RDFEV/RNFEV/ RPFEV Sensor Specification Change Notification

RDFEV/RNFEV/ RPFEV

Before	After
Dimension(Color:black)  	Dimension(Color:Cool Gray)

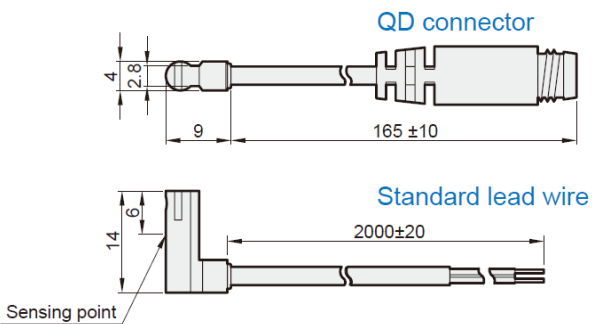
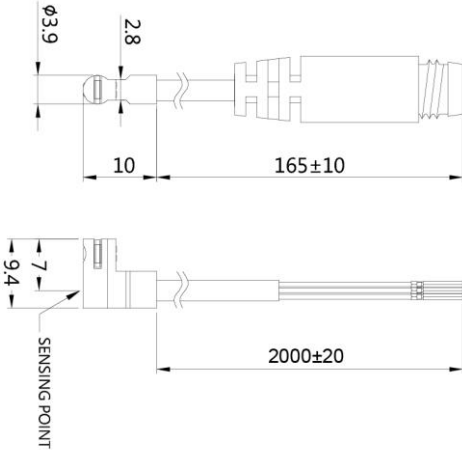
3. Design change

Before		After	
Specification		Specification	
Specification	RNFEV/RPFEV	Specification	RNFEV/RPFEV
Switching current	50 mA max.	Switching current	80 mA max.
Contact rating	1.5 W max.	Contact rating	2.2 W max.
Current consumption	10 mA @ 24 V DC max.	Current consumption	6 mA @ 24 V DC max.
